Product/Process Change Notice (PCN)

PCN #: ConUSB_20140626
Product Affected: 692221030100
Effective Date: 2014-10-15

<u>Old Design</u>	<u>New Design</u>

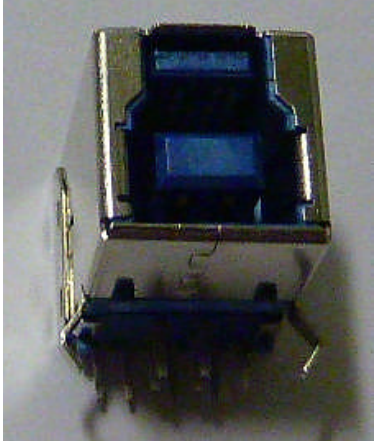
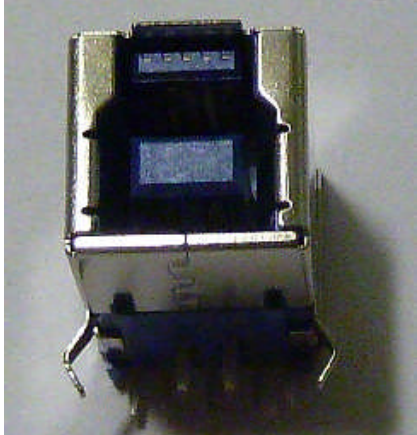
1. Color of insulator is changed to Pantone#653C to prevent it gets dark after soldering. Insulator material is the same.
2. Due to tooling change, the design of the insulator was modified to adapt to the automatic machine and to improve process control. Nevertheless, all electrical and mechanical properties and dimensions are remained the same.

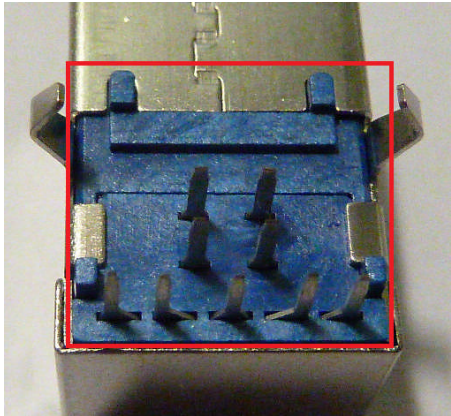
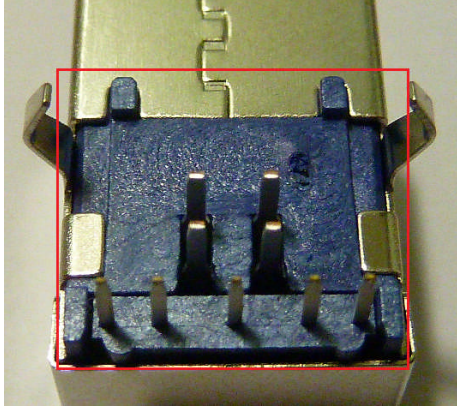
3. Dimension of tray is changed to adapt to the automatic machine. Nevertheless, tray design is kept the same.

<u>Old Packaging</u>			<u>New Packaging</u>		
<u>Tray dimension</u>	<u>Qty/Tray</u>	<u>Qty/Carton</u>	<u>Tray dimension</u>	<u>Qty/Tray</u>	<u>Qty/Carton</u>
345x245x17.5mm	120pcs	1440pcs	314x224x18mm	100pcs	1600pcs
